Informal document No. GRRF-62-02
(62nd GRRF, 25-28 September 2007,
agenda item 9.(e))

ASP- Additional Sidewall Protection

Presentation for GRRF
62nd session
25–28 September 2007

The “issue”

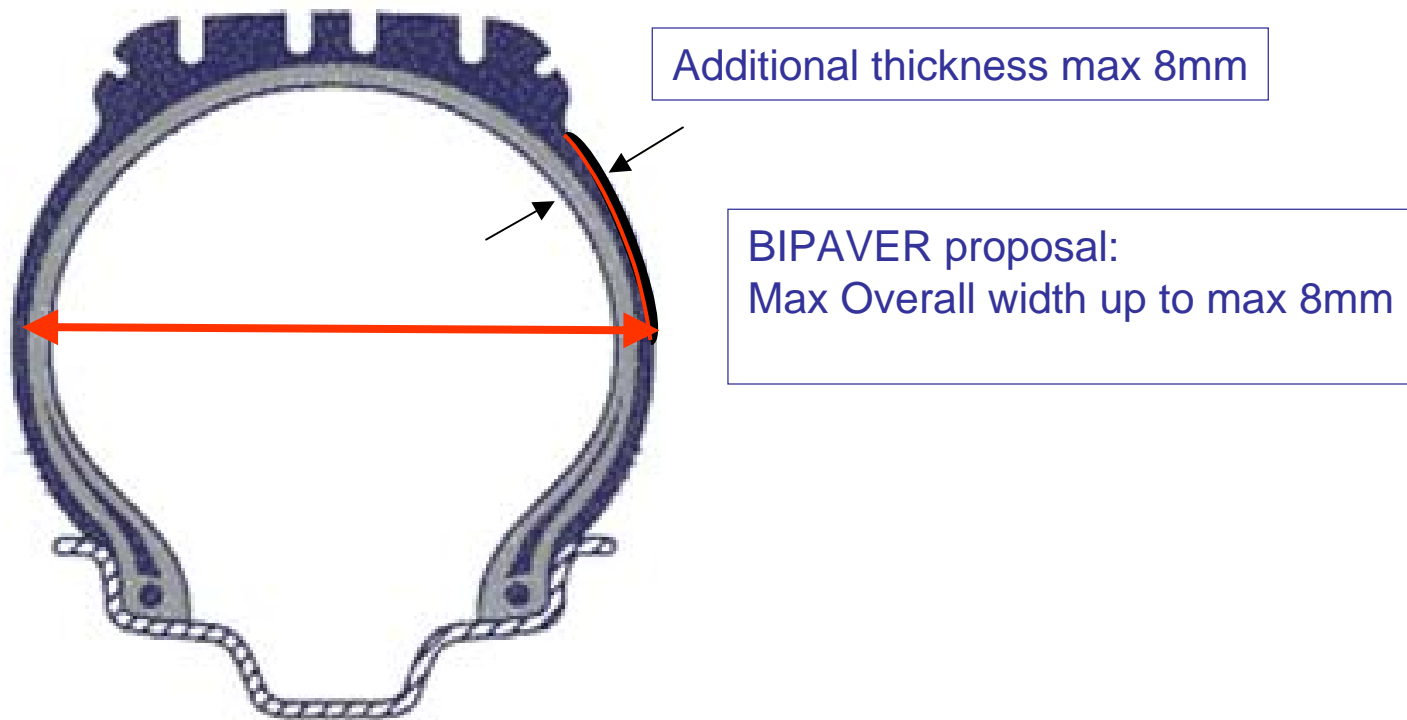
- For tyres with overall max section width limited to +2% the application of ASP might exceed max overall section width of ECE 109 :

- The BIPAVER proposal only deal with tyres exceeding max ECE-R109 Overall section width and **with a section width exceeding 305mm** .

Example: 315/80R22.5

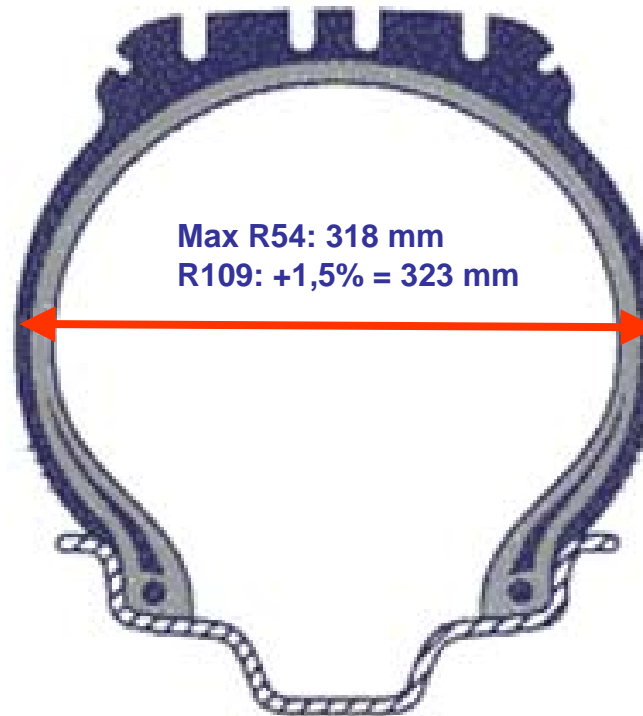
- Total section width is Max 8 mm wider than max section width of a new original tire permitted by Reg. 54.

Amended ECE 109: Max R54 + 1,5 % = 323 mm

Example: 315/80R22.5

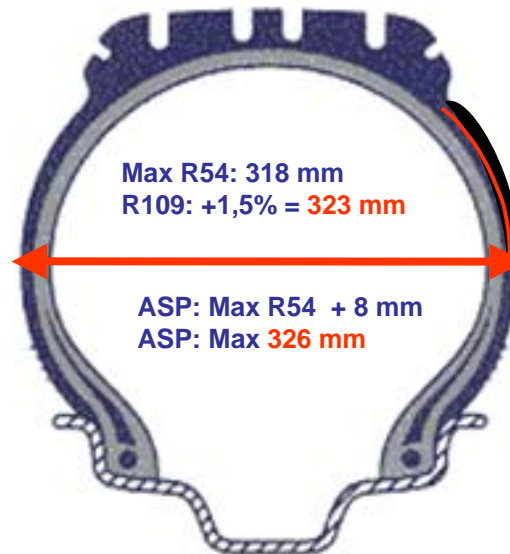
ASP only on **one side** permissible, when tyre is exceeding 323 mm !

Amended ECE 109: Max R54 + 1,5 % = 323 mm

No additional reduction
of dual spacing
vs. amended ECE 109

Marking **OUTSIDE**
